Appl. No. 10/708,157  
Amdt. dated September 26, 2005  
Reply to Office action of July 11, 2005

### REMARKS/ARGUMENTS

Fig. 16

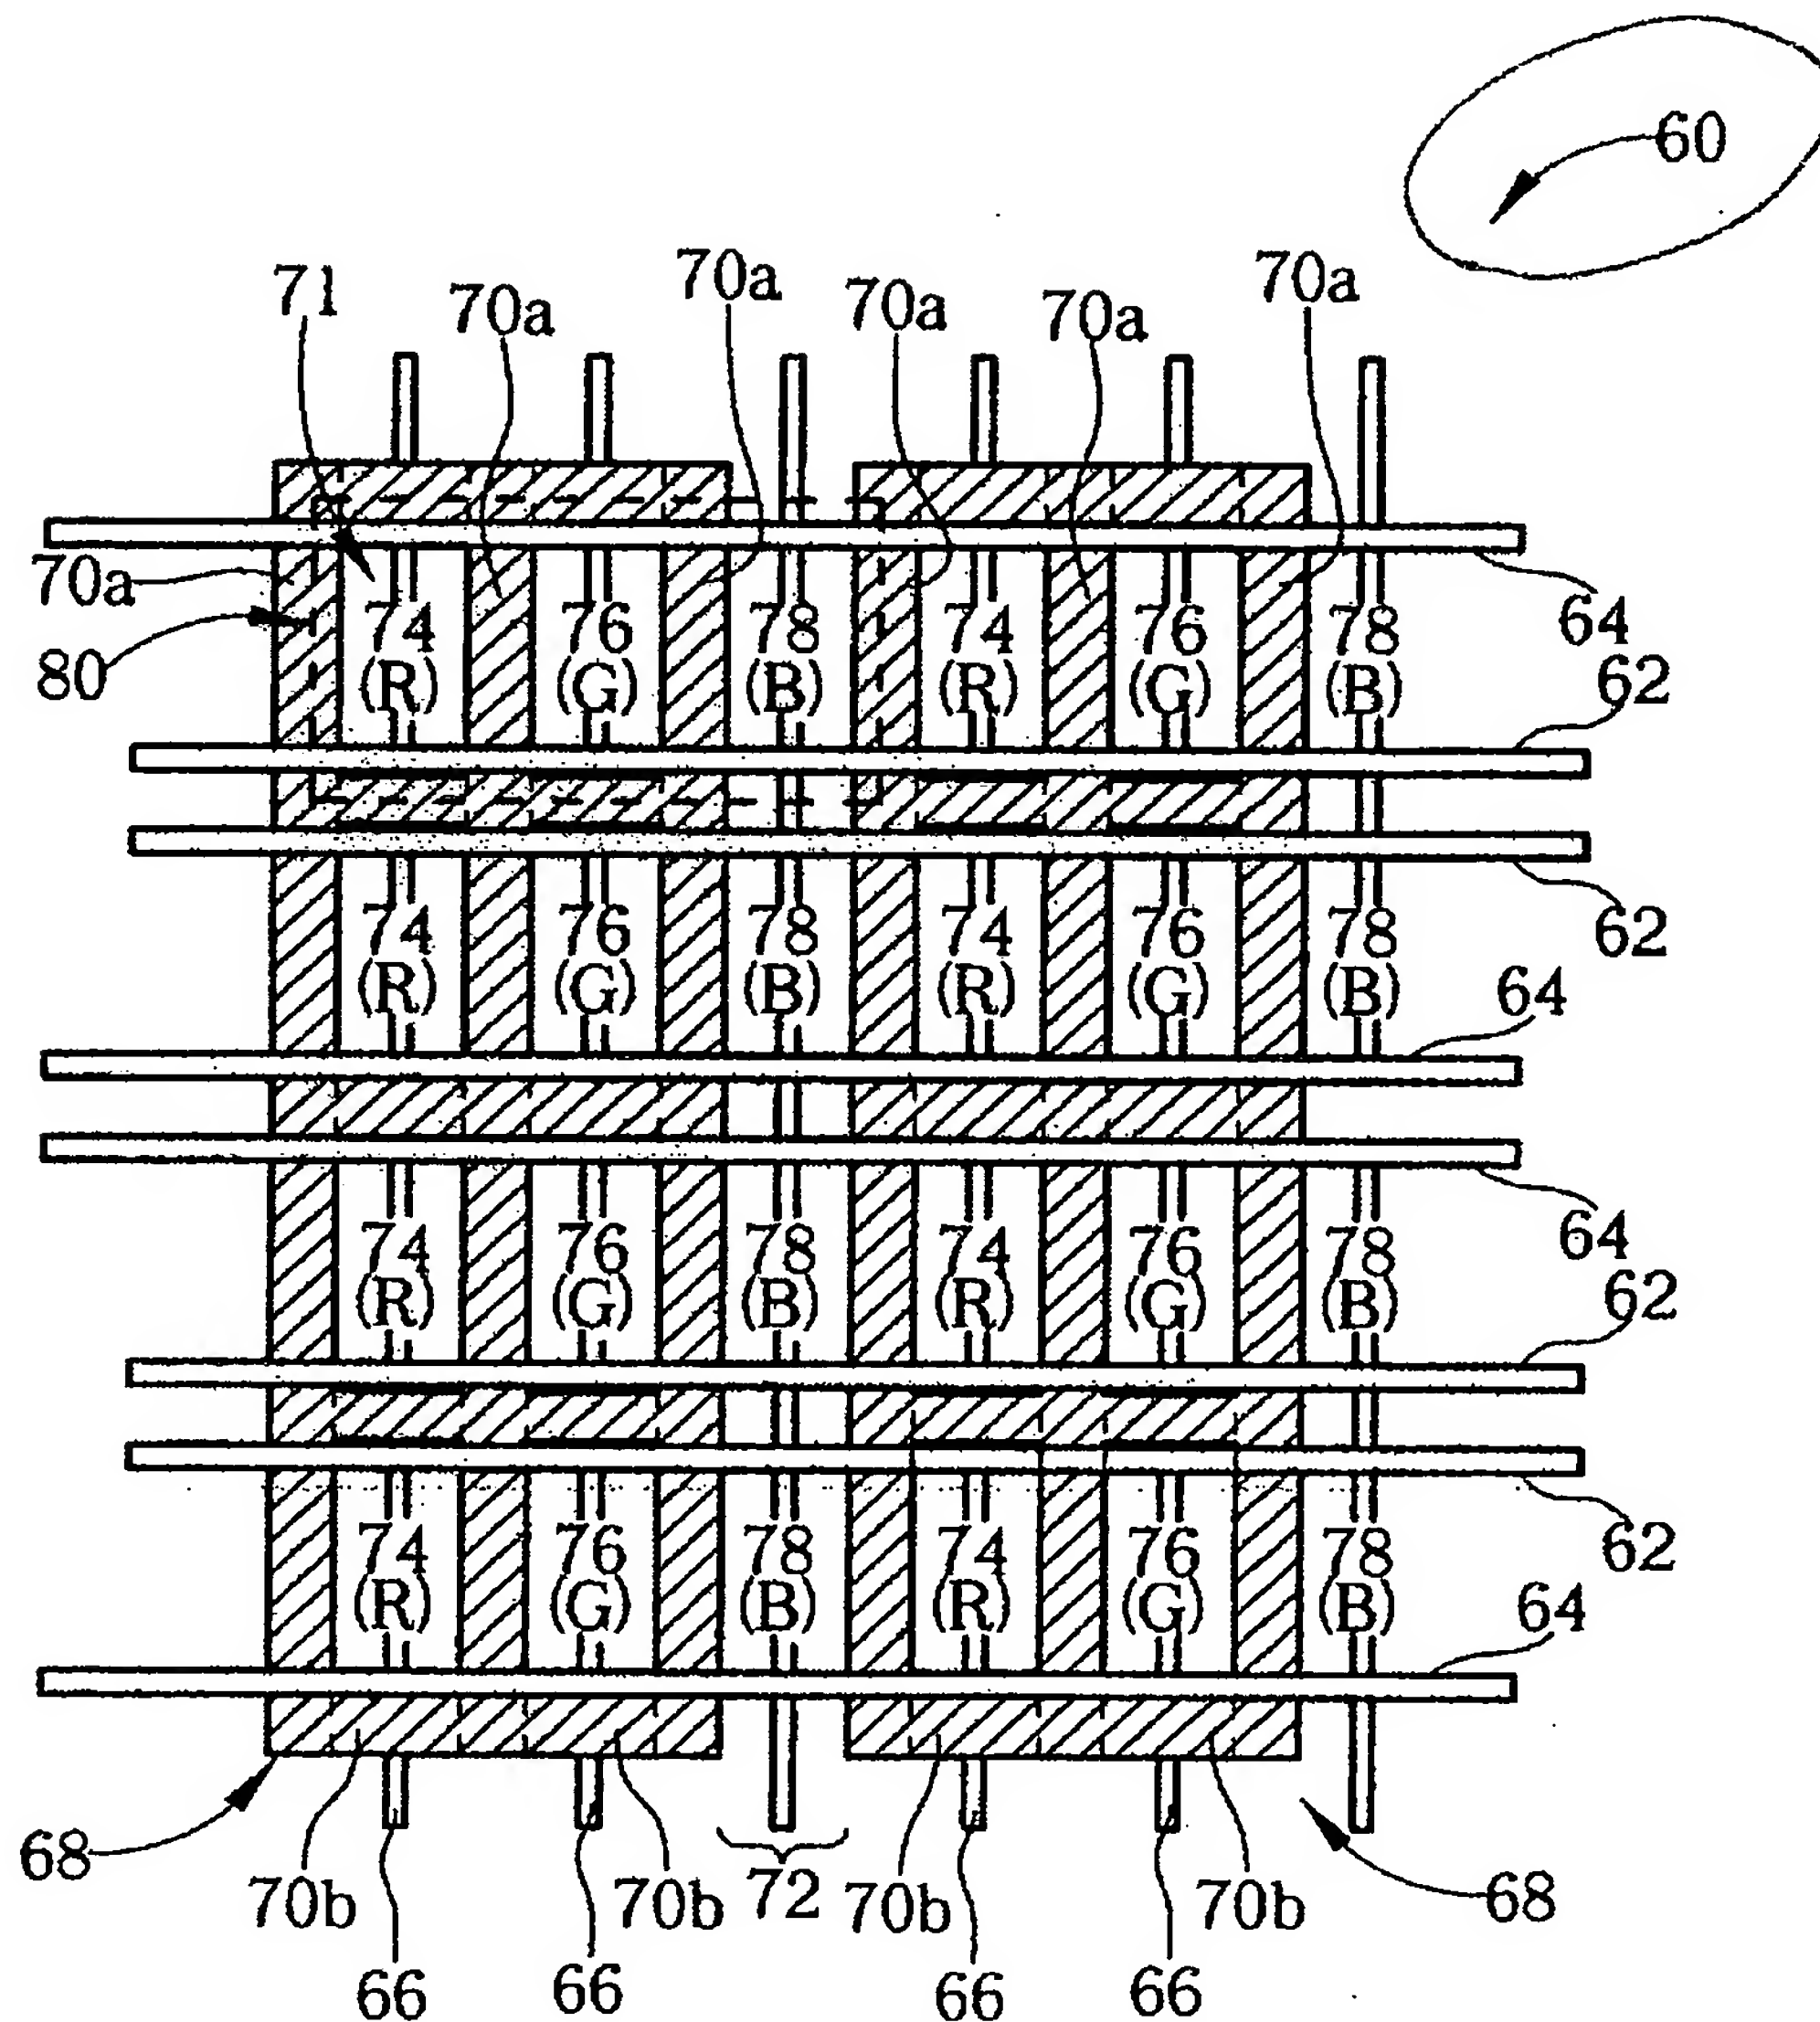
*1. The drawings are objected under 37 CFR 1.84(p)(5).*

Amendments to Figs. 2, 16-17 required by the Examiner to include the following reference signs mentioned in the description is made:

- (1) #14 in Fig. 2, depicting rear substrate in page 2 of the specification,  
10    (2) #60 in Fig. 16, depicting PDP of the fifth embodiment in paragraph 0028 of the specification,  
      (3) #90 in Fig. 17, depicting PDP of the sixth embodiment in paragraph 0030 of the specification.
